Public Works Department – Engineering Division

ADDENDUM NO. 4

PROJECT 5067 WTP FILTER IMPROVEMENTS AND HYPOCHLORITE CONVERSION

DWG. NO. S308

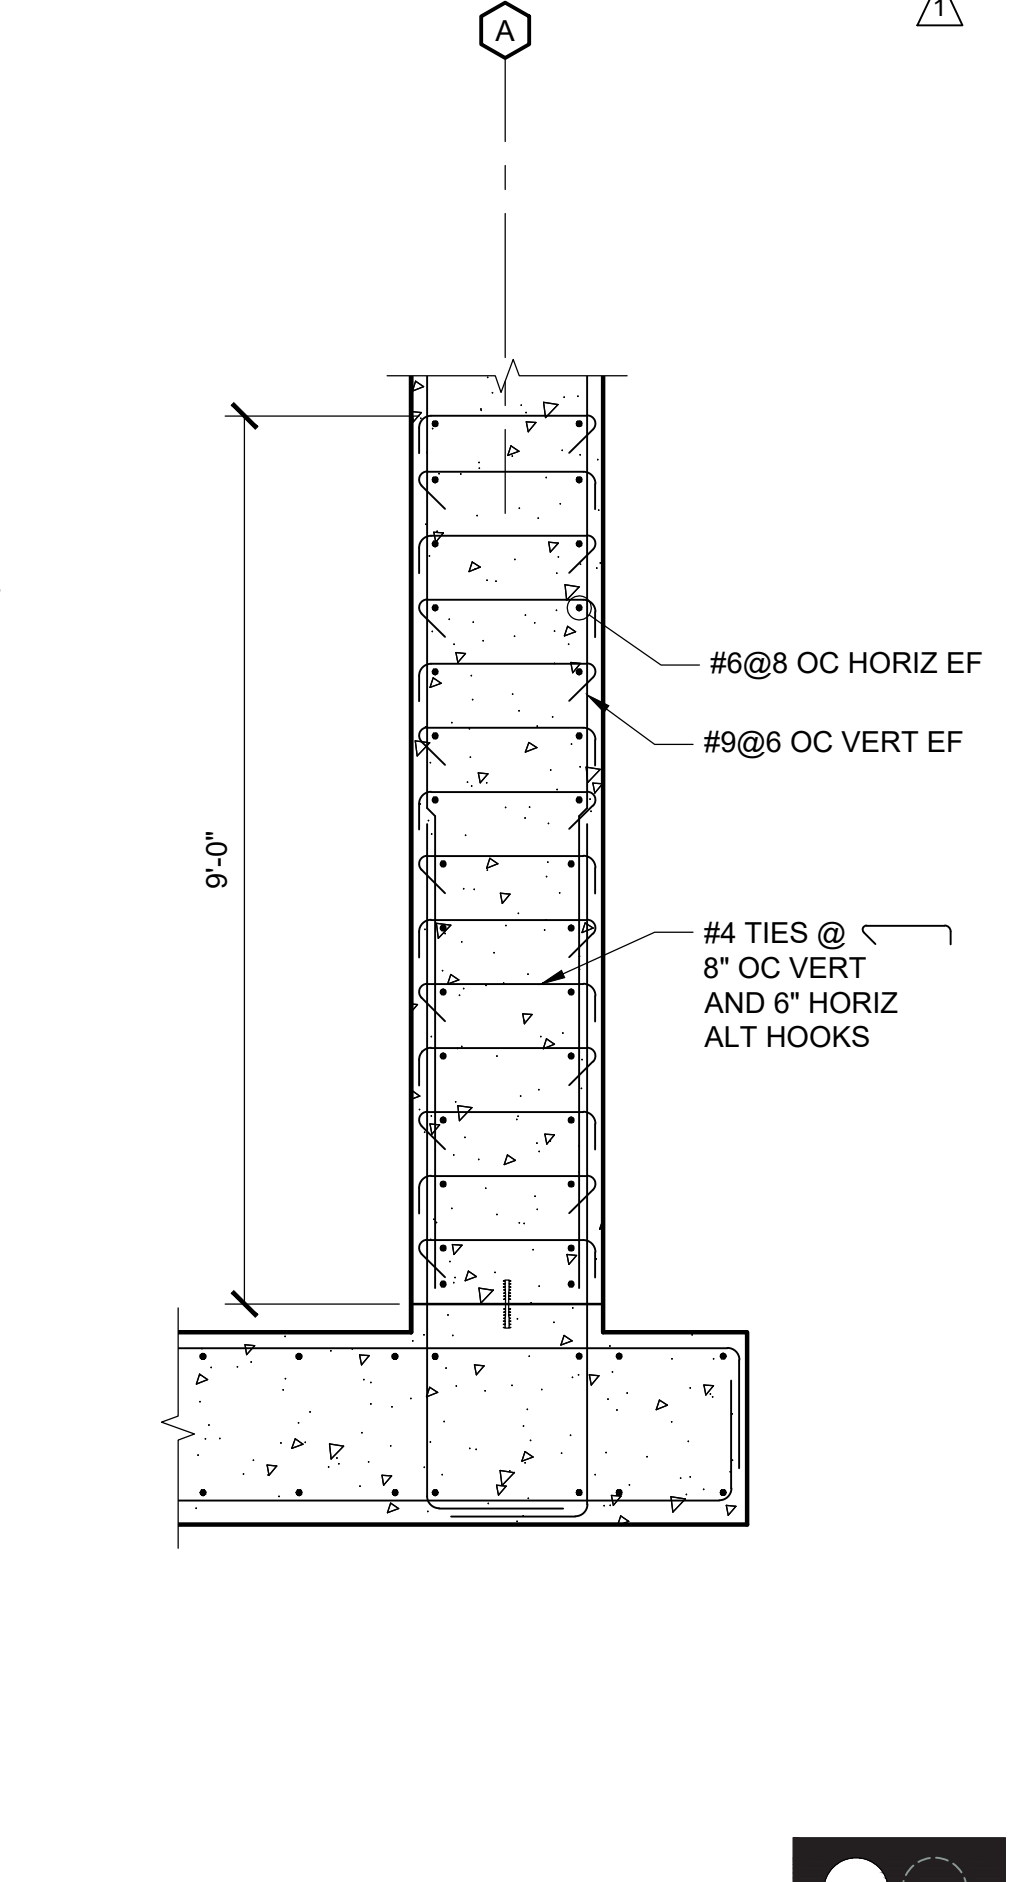
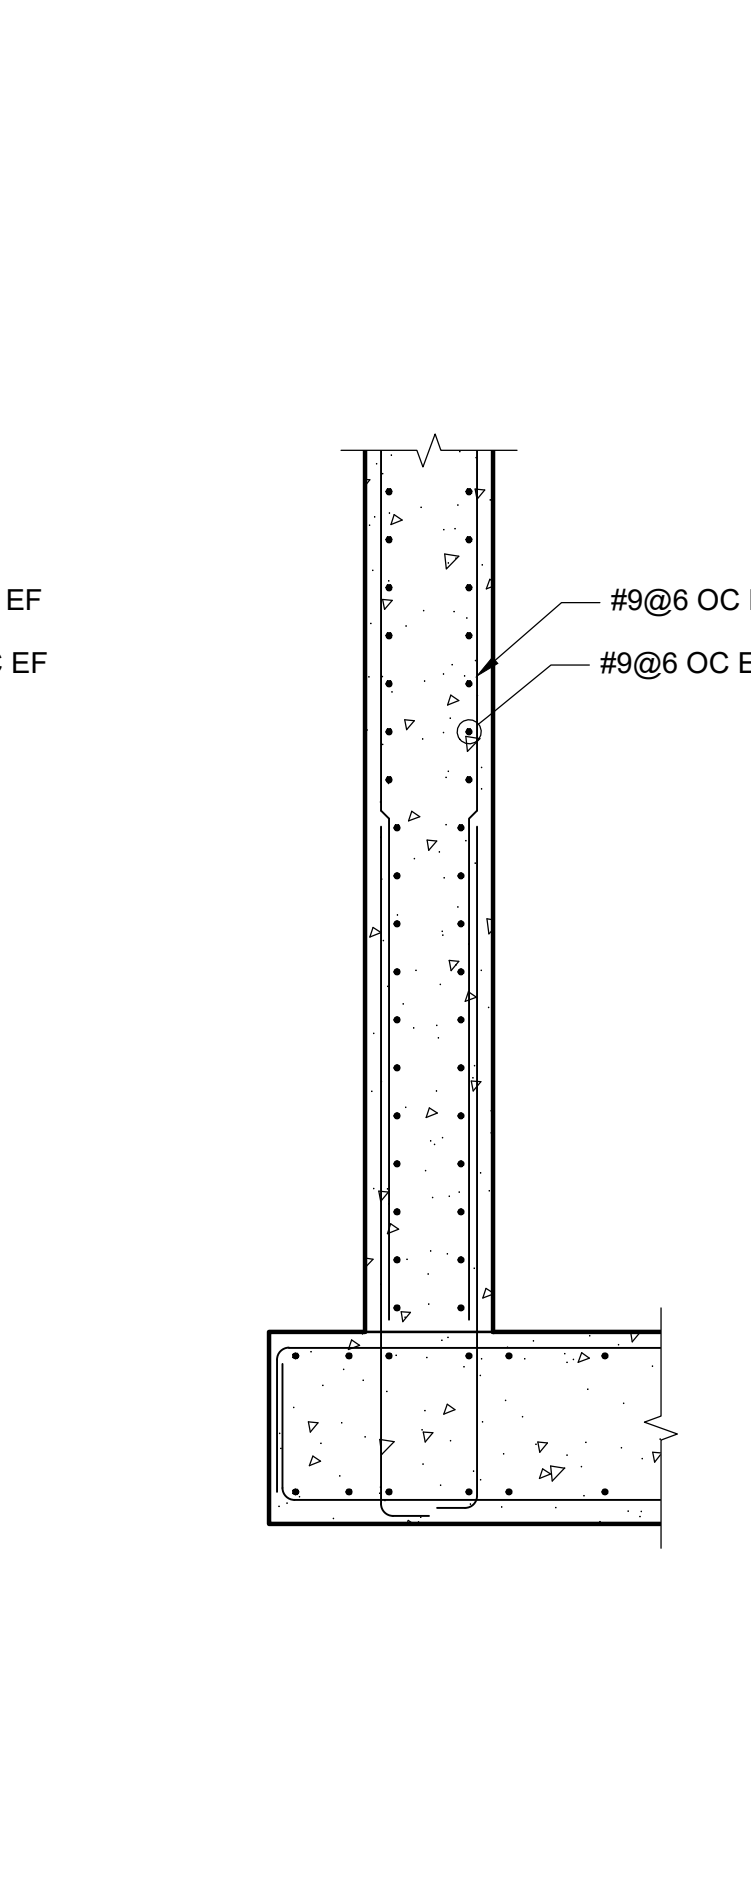
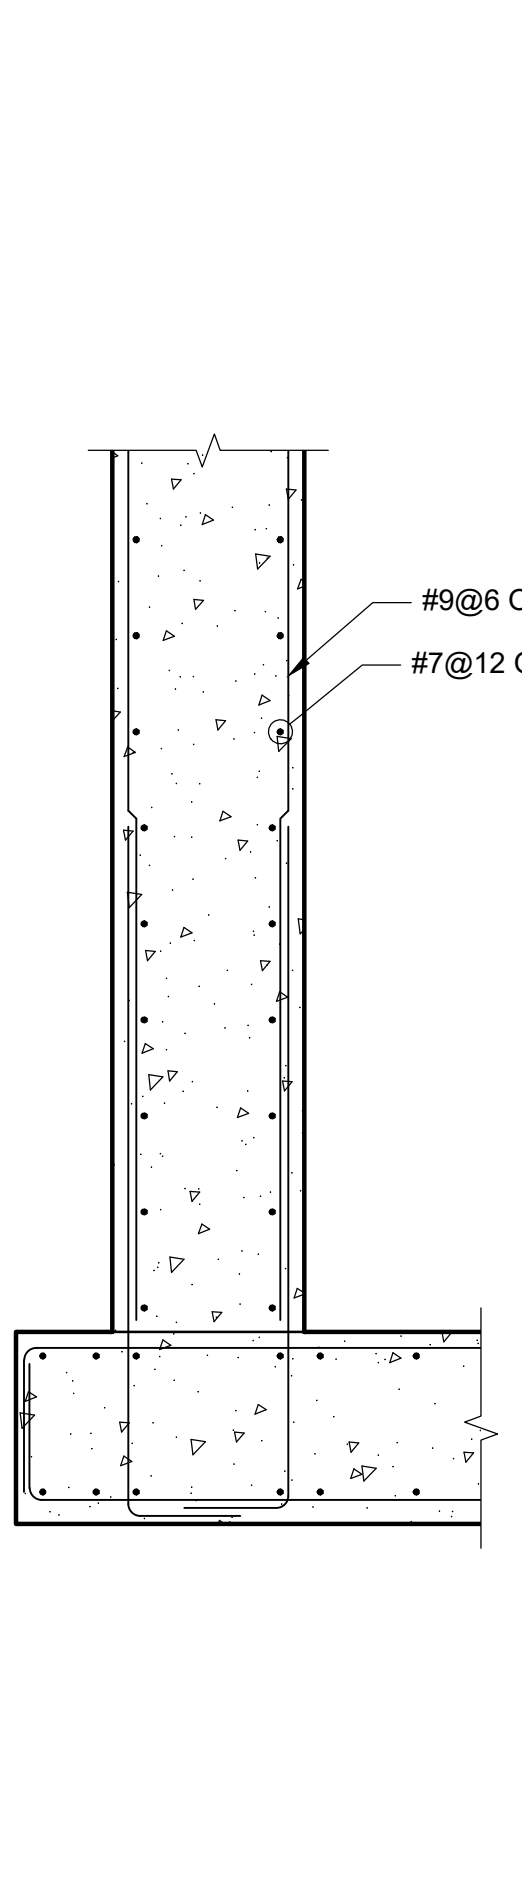
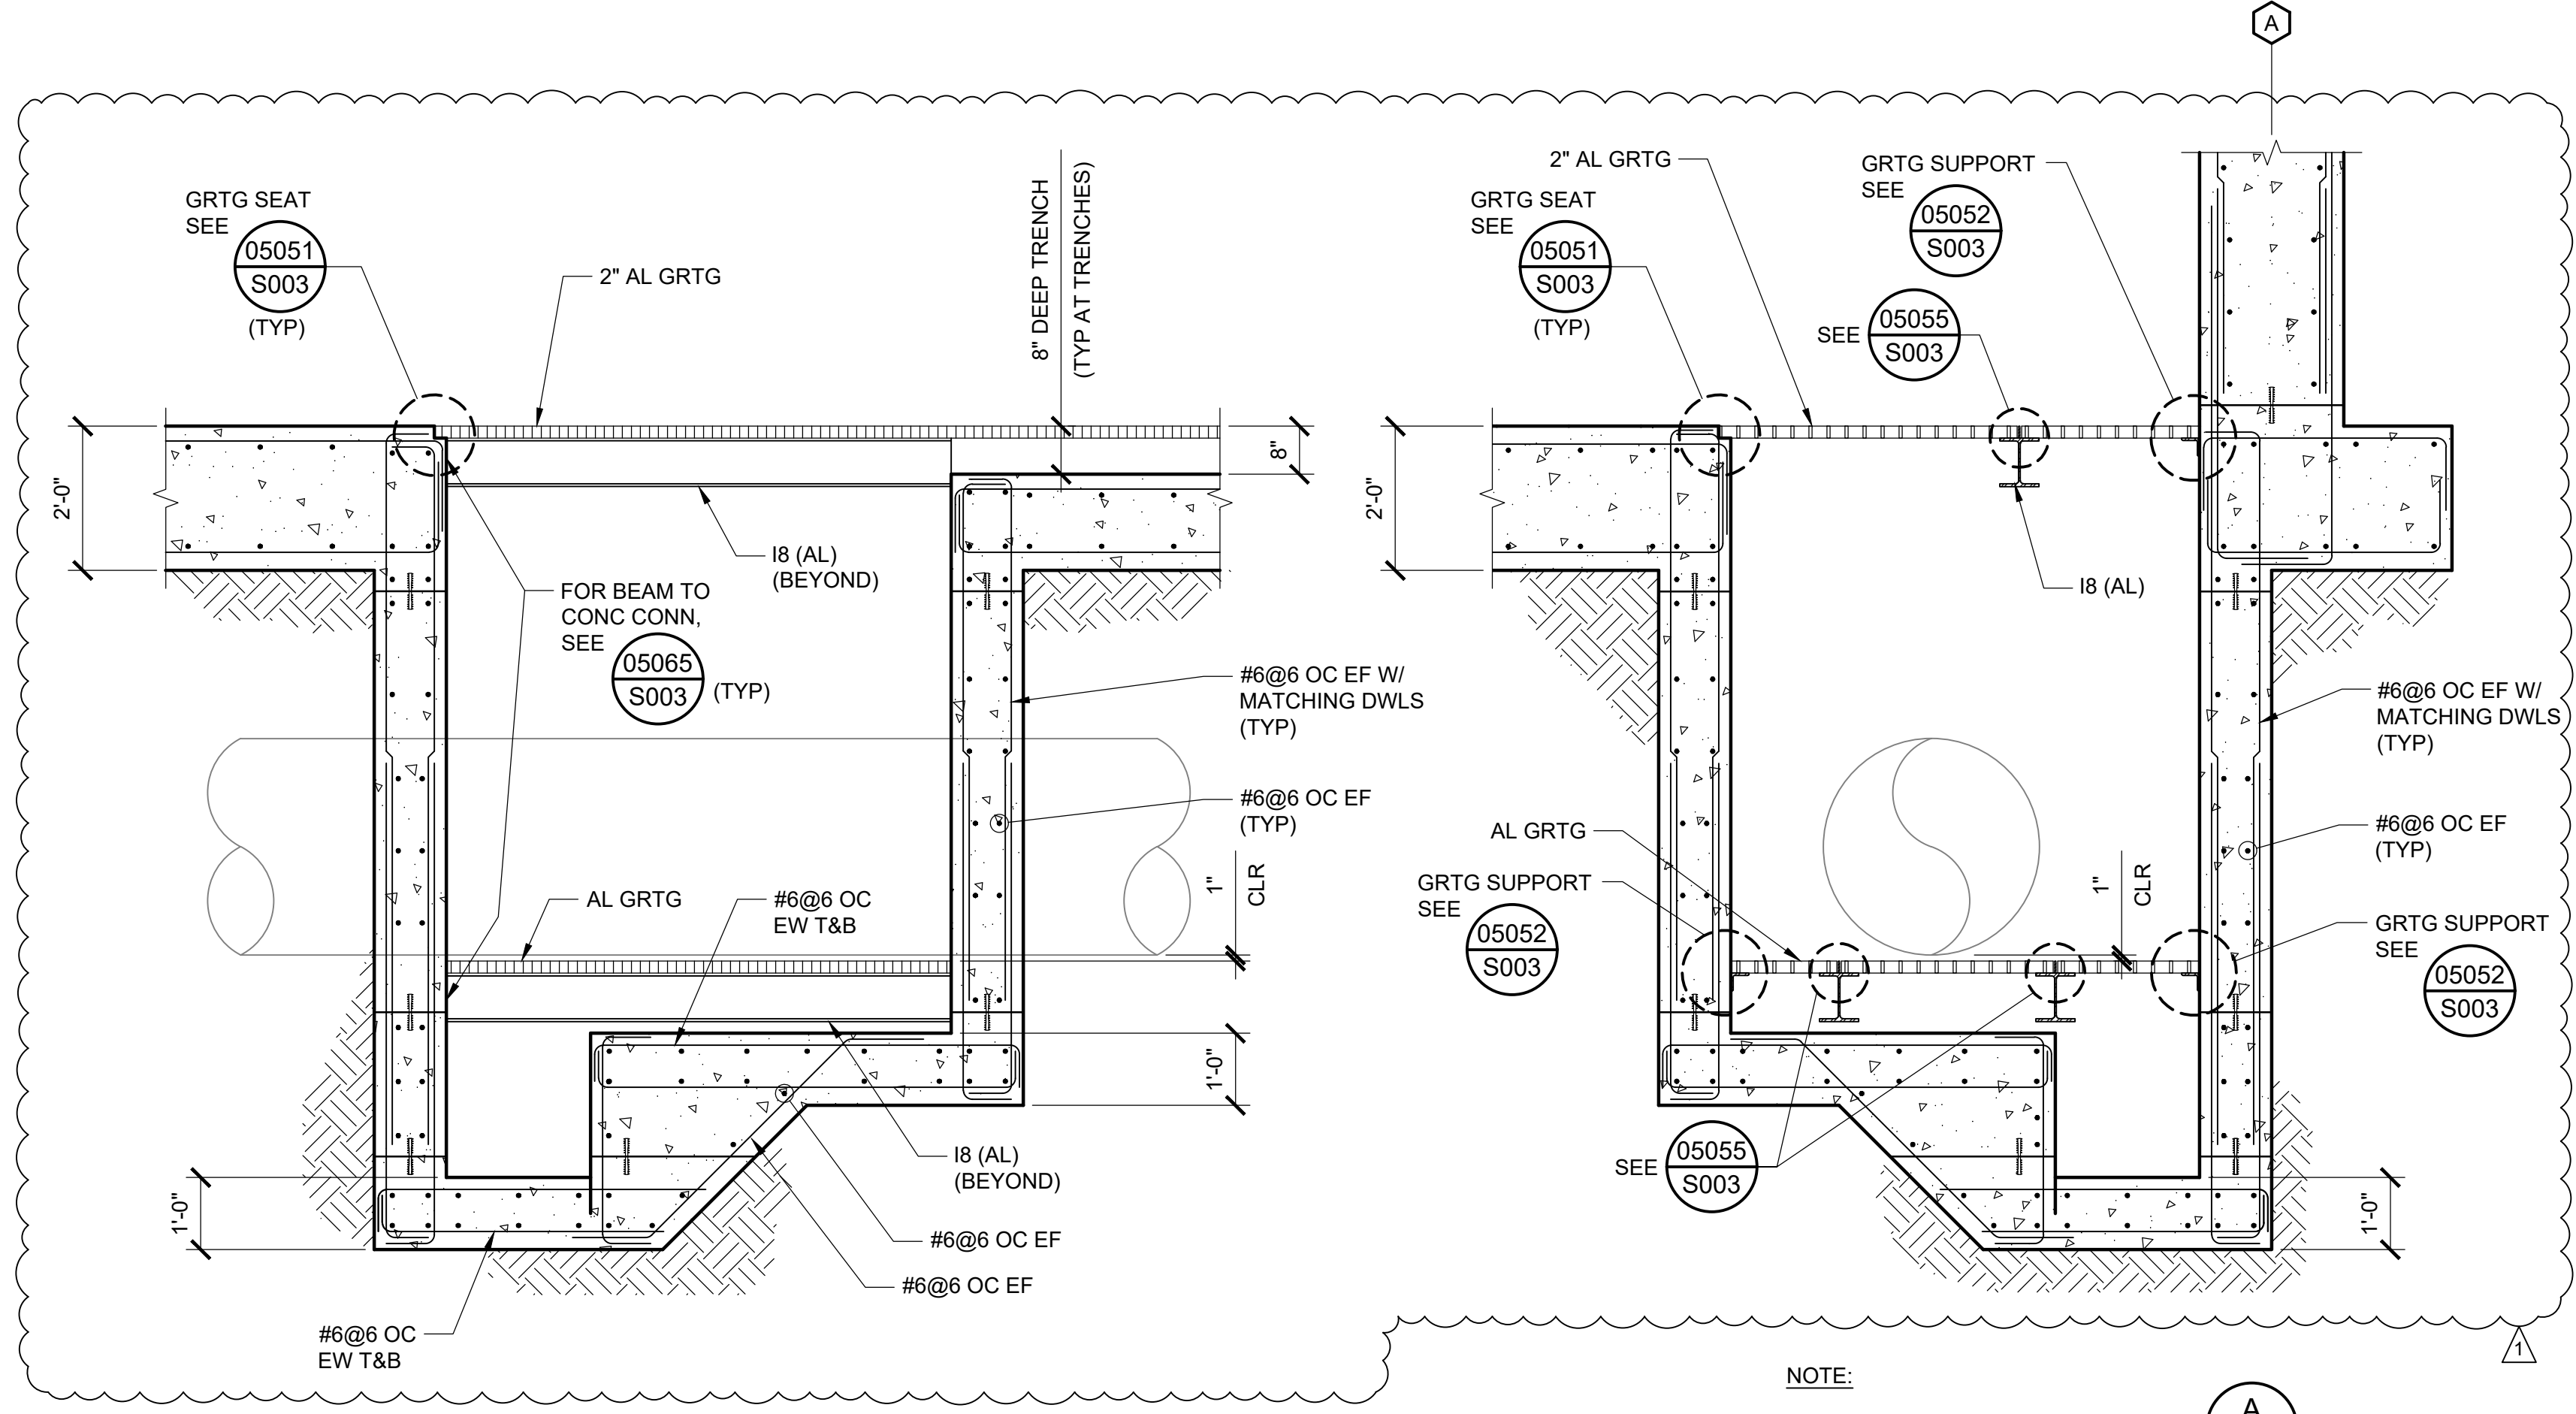
13. Replace Drawing C103 with the attached updated drawing C103.
14. Replace Drawing S308 with the attached updated drawing S308.
15. In Section 40 05 10, Part 2.2.N.1.b, add the following "Steel Plate Fabricators Association (SPFA) Quality Certification Program for Steel Pipe and Accessory Manufacturers, or the Lloyd's Register Quality Assurance" after "...shall conform to the requirements of ANSI/AWWA C200 and ISO 9001:2005 Certificate of Quality System Registration"

13. Contract drawing M313 calls out removable grating TYP see Structural drawings inside the CFE injection vaults, however there are no details in the structural

drawings indicating removable grating inside the injection vaults. Please provide the required details.

Response: Please see updated drawing S308 in this addendum, Item A.14.
